Attachment B

Selected Drawings

New The Salvation Army Accommodation & Mixed Use Development

PROJECT
Foster House
5-19 Mary St, Surry Hills NSW 2010

JOB NO	DRAWN	SCALE	DRAWING NO.
22.19	AR/JK	1:200	2.105
DATE	CHECKED	PLOT DATE	REVISION
24/5/22	PT		D

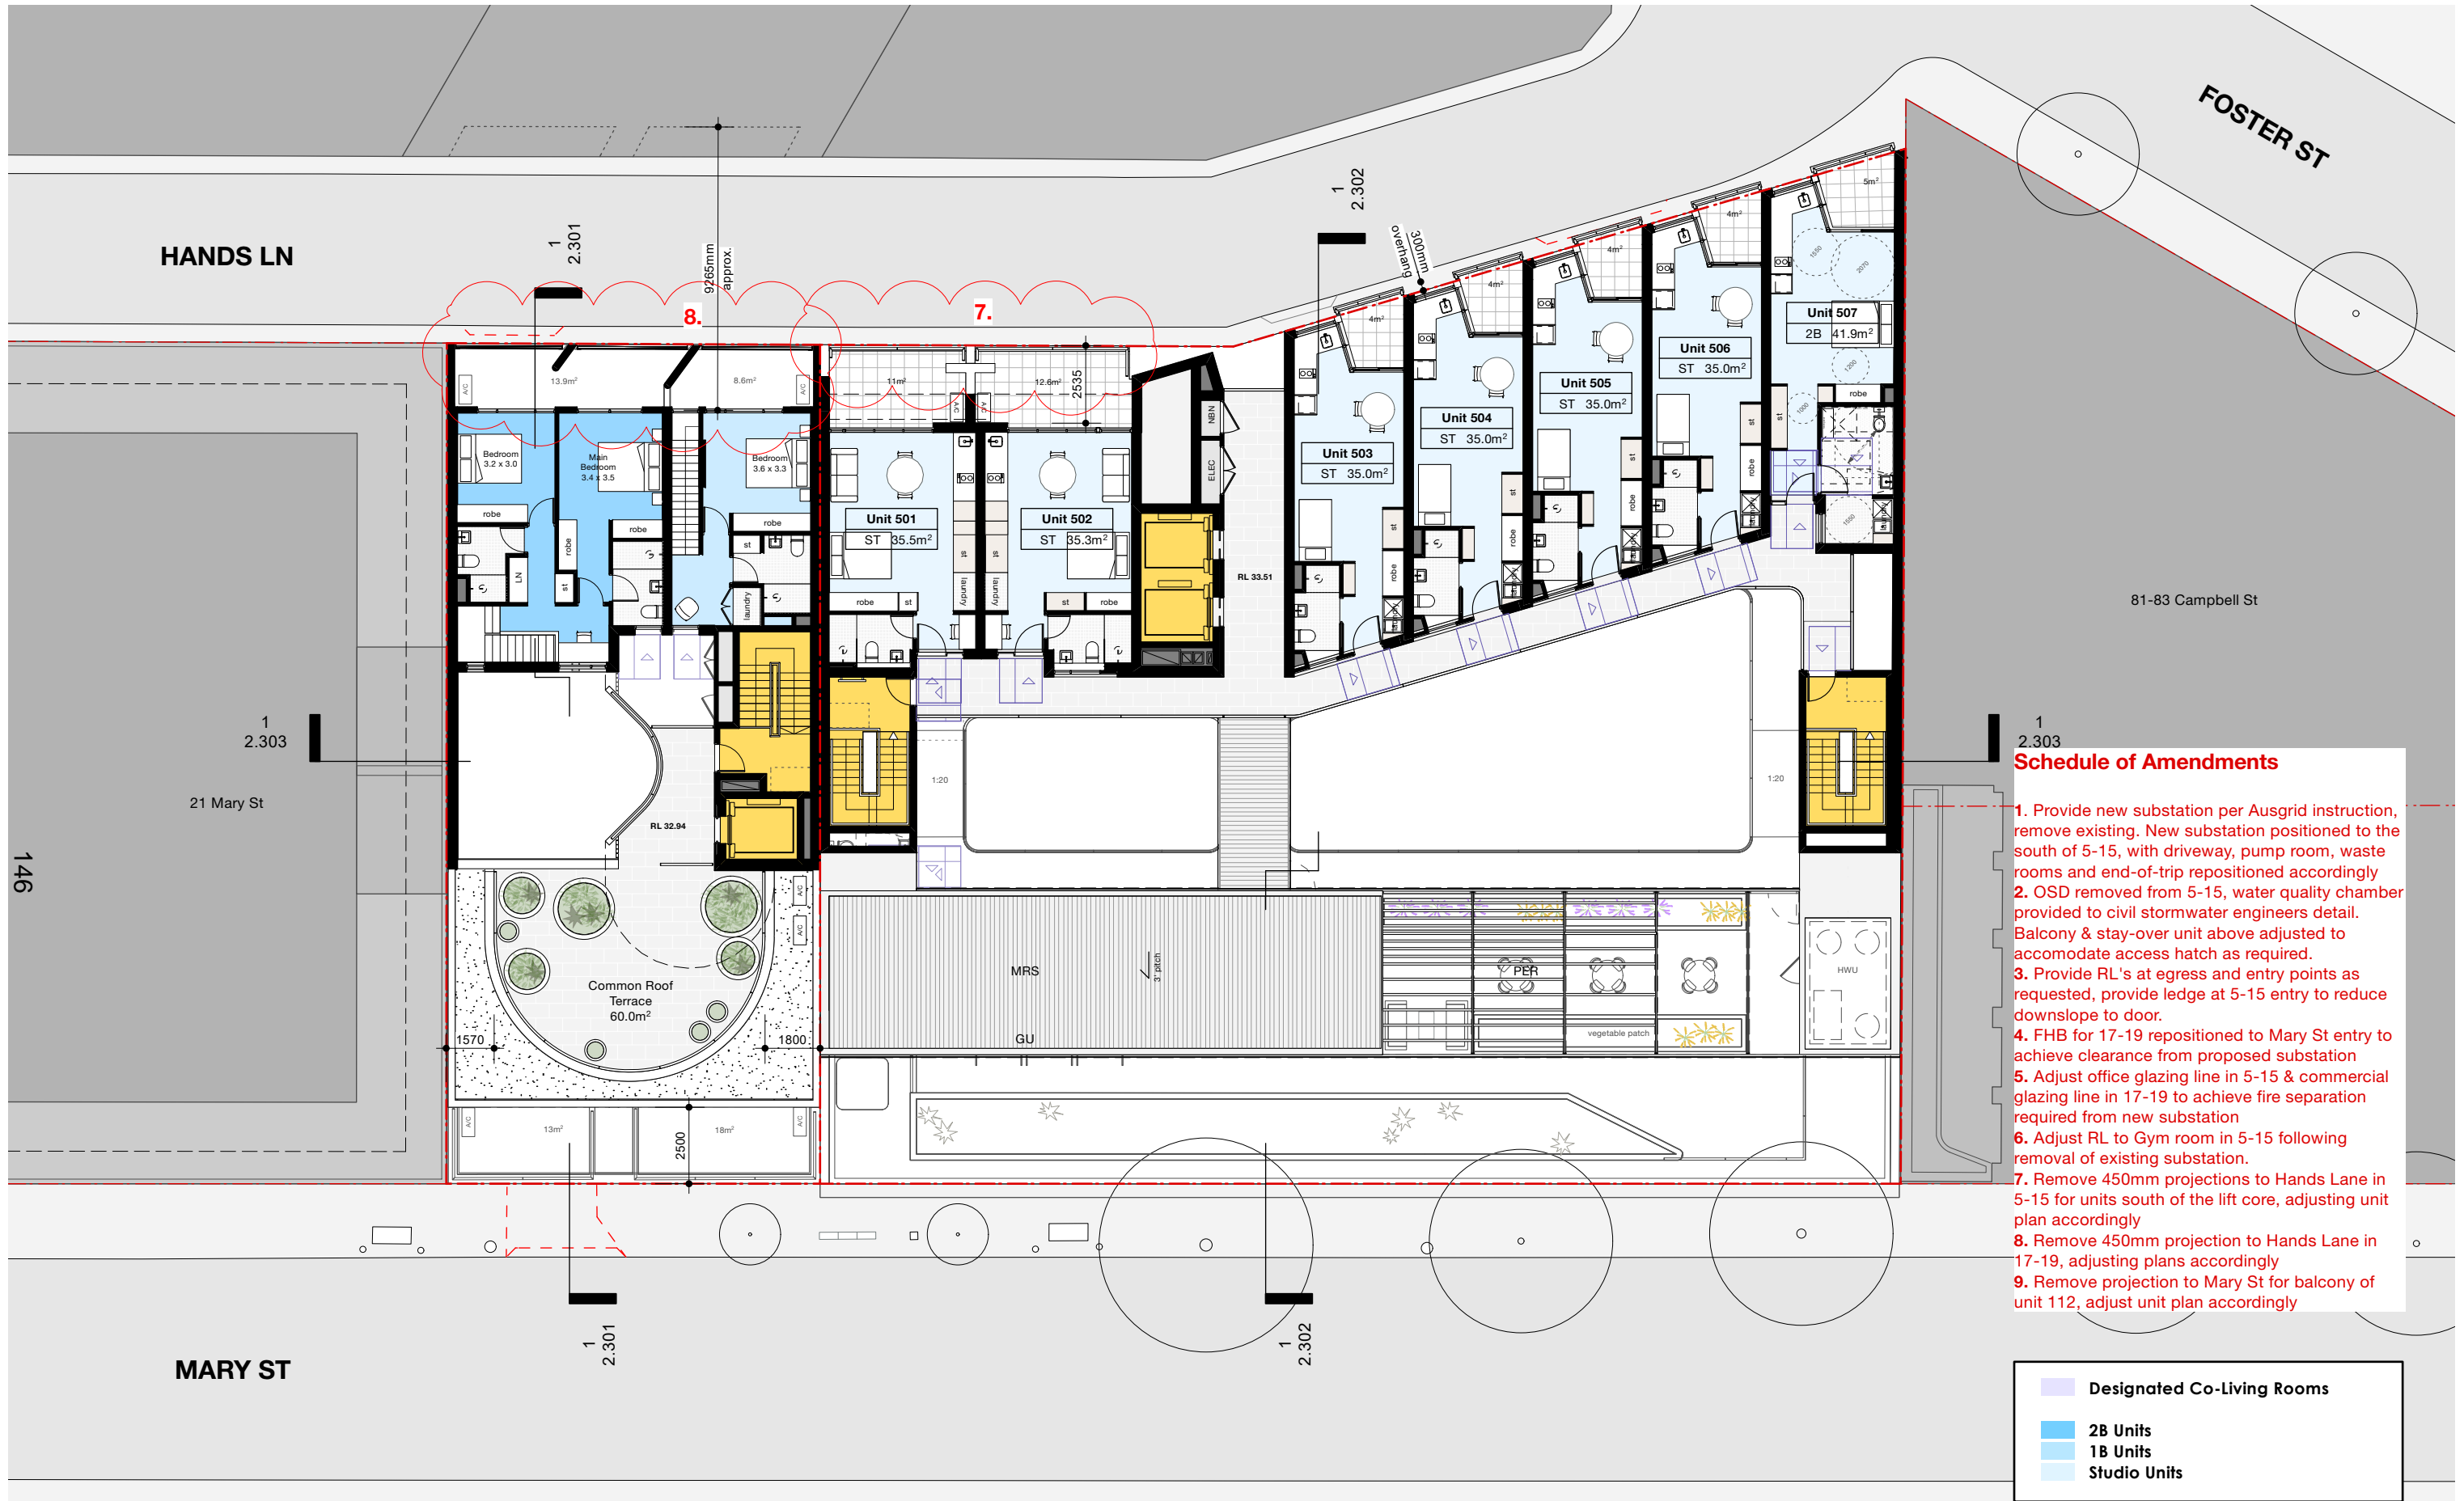
- Schedule of Amendments**
1. Provide new substation per Ausgrid instruction, remove existing. New substation positioned to the south of 5-15, with driveway, pump room, waste rooms and end-of-trip repositioned accordingly

2. OSD removed from 5-15, water quality chamber provided to civil stormwater engineers detail. Balcony & stay-over unit above adjusted to accommodate access hatch as required.

3. Provide RL's at egress and entry points as requested, provide ledge at 5-15 entry to reduce downslope to door.
 4. FHB for 17-19 repositioned to Mary St entry to achieve clearance from proposed substation

5. Adjust office glazing line in 5-15 & commercial glazing line in 17-19 to achieve fire separation required from new substation
 6. Adjust RL to Gym room in 5-15 following removal of existing substation.

7. Remove 450mm projections to Hands Lane in 5-15 for units south of the lift core, adjusting unit plan accordingly
 8. Remove 450mm projection to Hands Lane in 17-19, adjusting plans accordingly

9. Remove projection to Mary St for balcony of unit 112, adjust unit plan accordingly

DRAWING TITLE			
			Roof Plan
JOB NO	DRAWN	SCALE	DRAWING NO.
22.19	AR/JK	1:200	2.107
DATE	CHECKED	PLOT DATE	REVISION
24/5/22	PT		D

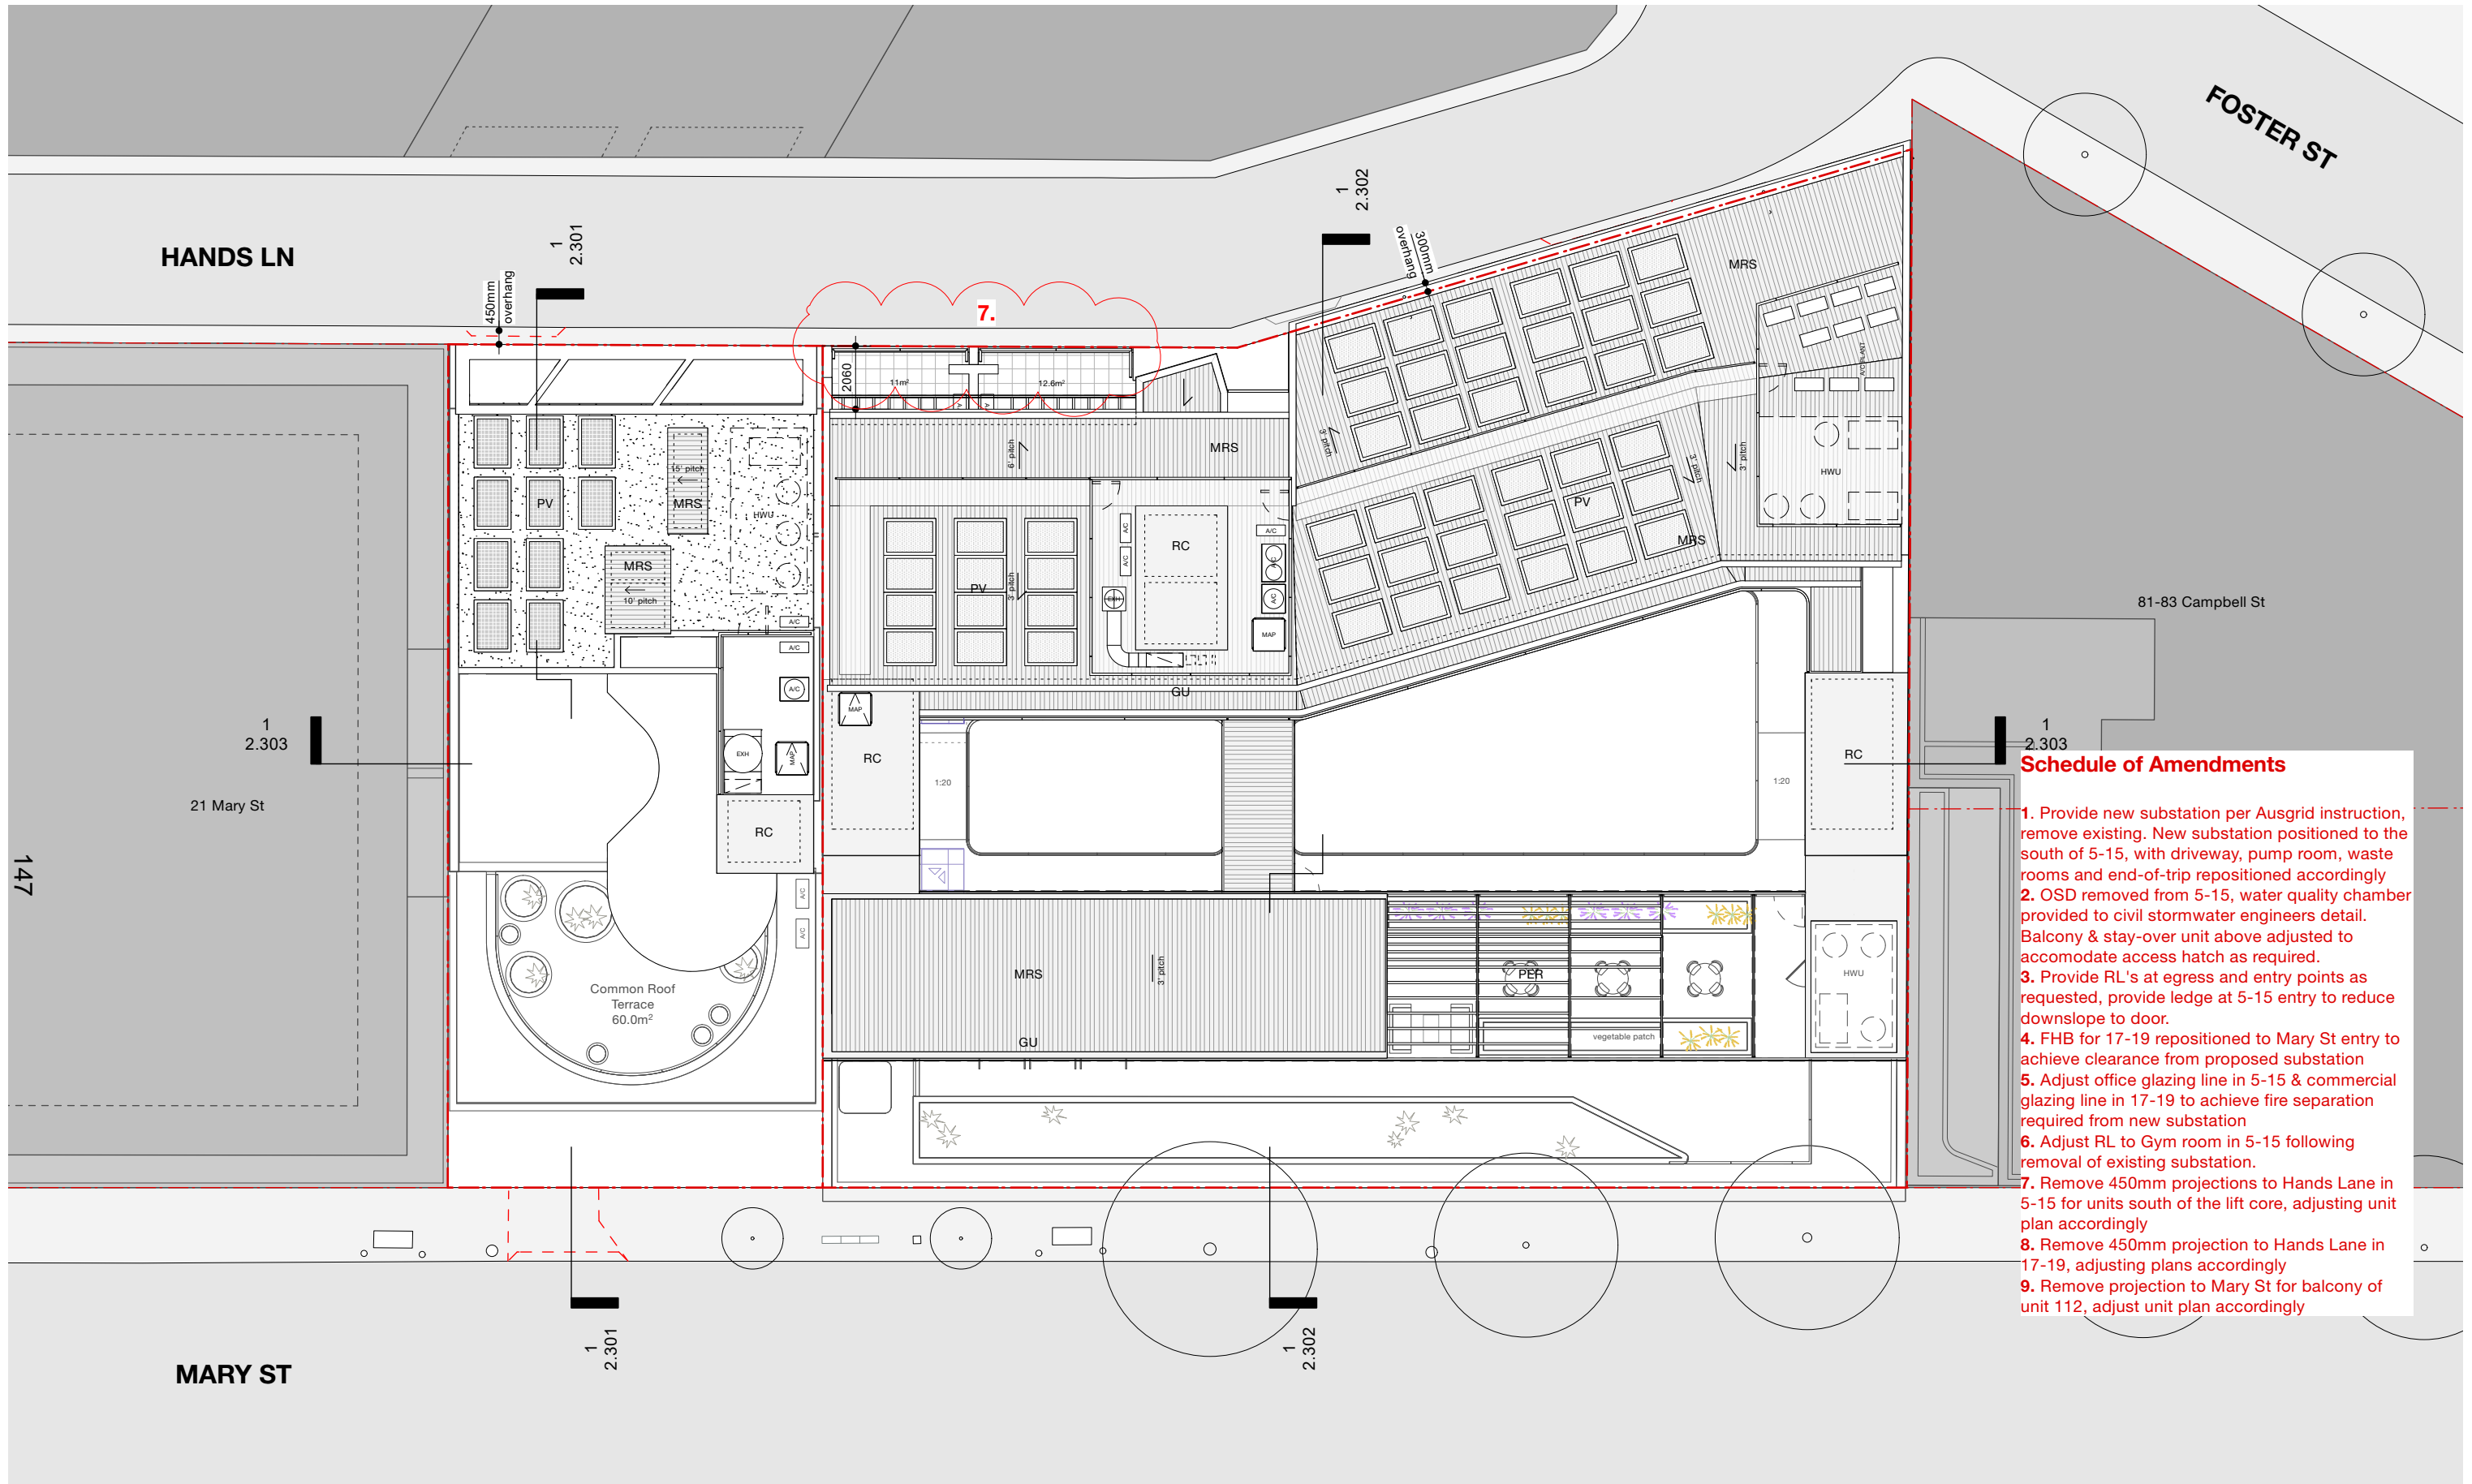
Schedule of Amendments

1. Provide new substation per Ausgrid instruction, remove existing. New substation positioned to the south of 5-15, with driveway, pump room, waste rooms and end-of-trip repositioned accordingly

2. OSD removed from 5-15, water quality chamber provided to civil stormwater engineers detail. Balcony & stay-over unit above adjusted to accommodate access hatch as required.

3. Provide RL's at egress and entry points as requested, provide ledge at 5-15 entry to reduce downslope to door.
4. FHB for 17-19 repositioned to Mary St entry to achieve clearance from proposed substation

5. Adjust office glazing line in 5-15 & commercial glazing line in 17-19 to achieve fire separation required from new substation
6. Adjust RL to Gym room in 5-15 following removal of existing substation.

7. Remove 450mm projections to Hands Lane in 5-15 for units south of the lift core, adjusting unit plan accordingly
8. Remove 450mm projection to Hands Lane in 17-19, adjusting plans accordingly

9. Remove projection to Mary St for balcony of unit 112, adjust unit plan accordingly
